SUBJECT: Indian Point 3 Nuclear Power Plant  
Docket No. 50-286  
**Supplement to Proposed Change to Technical Specifications Regarding  
Post Accident Monitoring Instrumentation**

## ENTERGY RESPONSES TO NRC REVIEWER COMMENTS

**PROPOSED TECHNICAL SPECIFICATION CHANGES REGARDING  
POST ACCIDENT MONITORING INSTRUMENTATION**

**SAFETY EVALUATION FOR  
PROPOSED TECHNICAL SPECIFICATION CHANGE REGARDING  
POST ACCIDENT MONITORING INSTRUMENTATION**

INSERT FOR BASES PAGE B 3.3.3 -11:

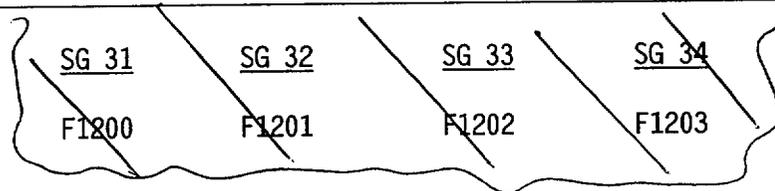
14. Steam Generator Water Level (Wide Range) and Auxiliary Feedwater Flow

Each steam generator has one level transmitter that spans a range from the tube sheet up to the moisture separator. Wide range SG water level is a Category I, Type A variable used to determine if the SG's are being maintained as an adequate heat sink for decay heat removal. Since there is only one instrument channel per steam generator, Auxiliary Feedwater (AFW) flow instrumentation is credited for providing a redundant means of determining if adequate decay heat removal by the SGs is being maintained. Although not a category I or Type A variable for IP3, the AFW flow instrument channels provide redundancy for SG wide range level in the event of the limiting single failure of a power supply. The LCO requirement for this function is satisfied by one SG wide range water level channel and one AFW flow channel for each steam generator. The instrument channels for SG wide range water level are designated LT-417D, LT-427D, LT-437D, and LT-447D. The instrument channels for AFW flow are designated F1200, F1201, F1202, and F1203.

15. NOT USED
